**TESTIMONY OF JOE MEHRA, P.E. PTOE, IN OPPOSITION TO THE 923-925 5<sup>th</sup> Street NW, Hotel, BZA Case No. 19722. (May 17, 2018)**

I have reviewed the Revised Comprehensive Transportation Review (CTR) study prepared by Gorove/Slade, dated May 4, 2018 and the response to my report submitted to BZA (response by Gorove/Slade is dated May 3, 2018) and DDOT Report dated May 11, 2018. Based on my review, I continue to conclude that the Gorove/Slade CTR is incomplete and does not meet the CTR Guidelines. Further, the Loading Dock access would not function based on the data and information provided by Gorove/Slade in their revised report.

PHOTO Q

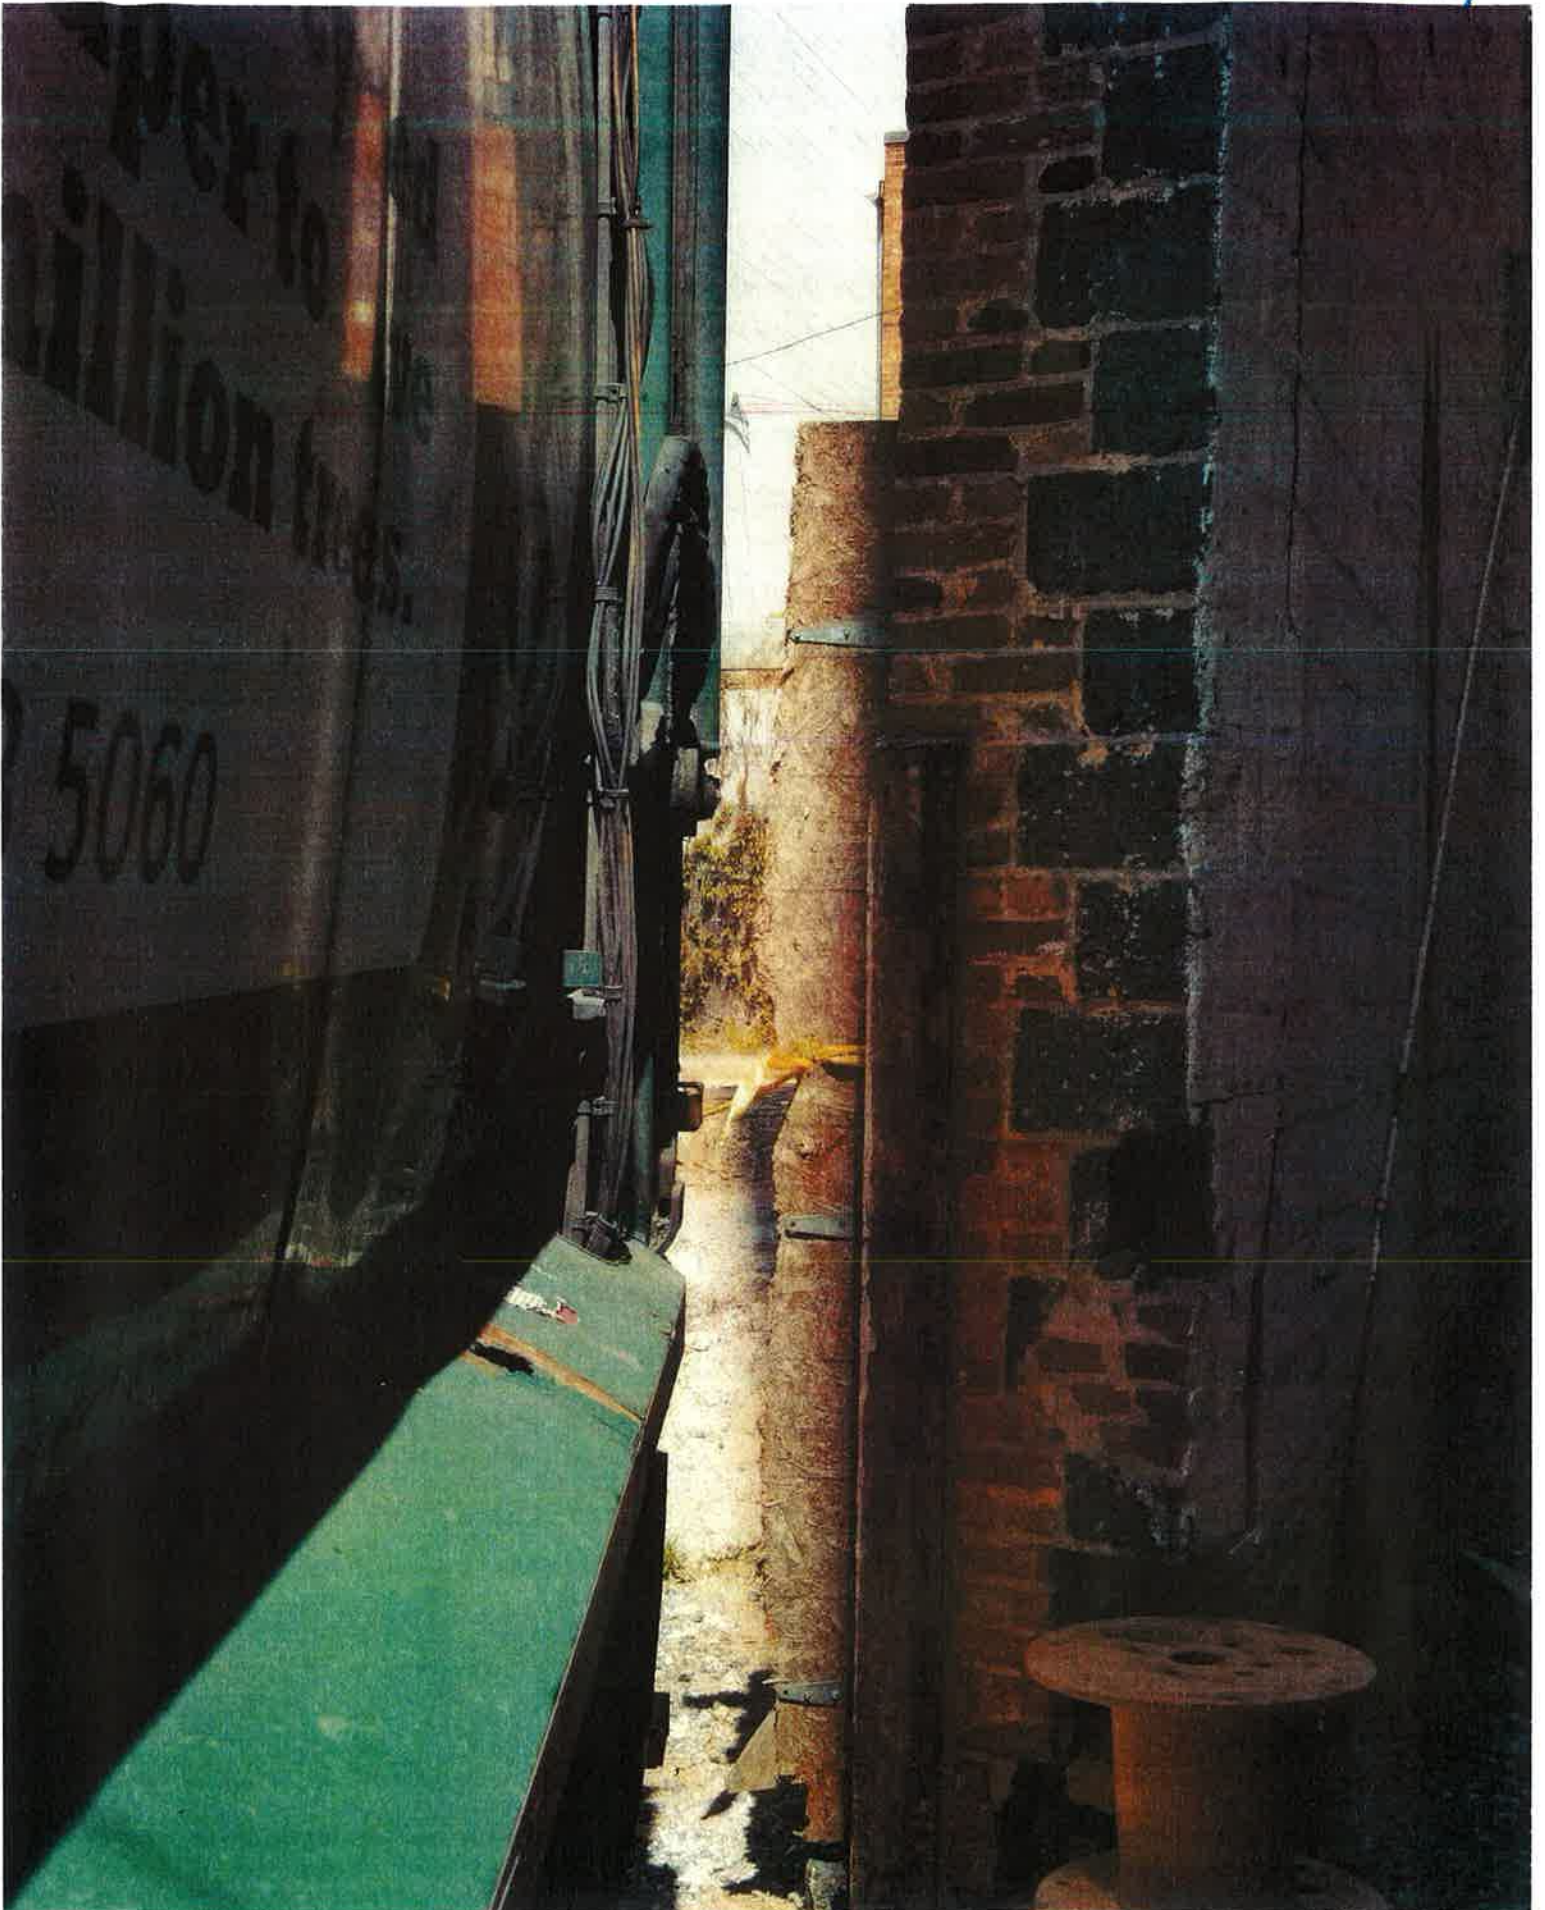
- P**     Truck backing into the loading dock area with assistant.
- Q**     Margin of error backing into the hotel loading dock.
- R**     Trash truck driver waiting to leave the area.
